Bi-Weekly Seismic Call Meeting Agenda
1-888-405-5619 (Toll free) – Participant Code: 11140

Open Item Tracking List
NRC Audit 3.7/3.8 - June 20 - 24, 2016

Topics:

26. RAI 208-8245, Question 03.08.03-6

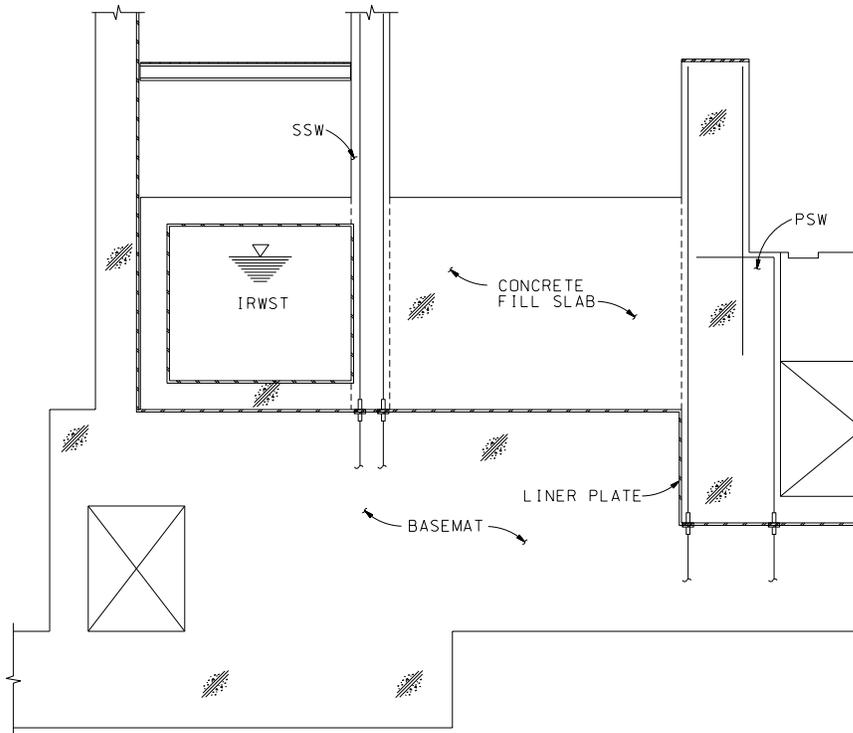
1. The applicant response to part 1 is acceptable - Confirmatory Item
2. The applicant response to part 2 states, "The impulsive mode primarily acts to stress the wall, whereas the convective mode acts primarily to uplift the wall." The applicant is requested to clarify this statement. The convective mode also applies stresses on the IRWST and should be combined with the impulsive mode. The applicant is also requested to explain what is meant by the statement: "Therefore, considering the impulsive mode over the water level is more conservative than considering both impulsive and convective modes," and why considering only the impulsive mode is more conservative.
3. The applicant response to part 3 is acceptable - resolved/closed.
4. The applicant response to part 4 is acceptable - resolved/closed.

Consider the height of water is H (i.e. $H = H1 + H2$) which consists of convective height ($H1$) and impulsive height ($H2$). As mentioned above, the pressures due to the height $H1$ and $H2$ acts in different phase with each other and the convective effect is smaller than the impulsive effect. The terms "considering the impulsive mode over the water level" means that the pressure of the height H ($H1 + H2$) is considered as the impulsive mode and not the pressure in the height $H2$ is only being considered as the impulsive mode. Therefore, the pressure considering the impulsive mode over the water level (H) is more conservative than considering both impulsive ($H2$) and convective ($H1$) modes.

The revised final RAI response will be submitted on 07/18/2016.
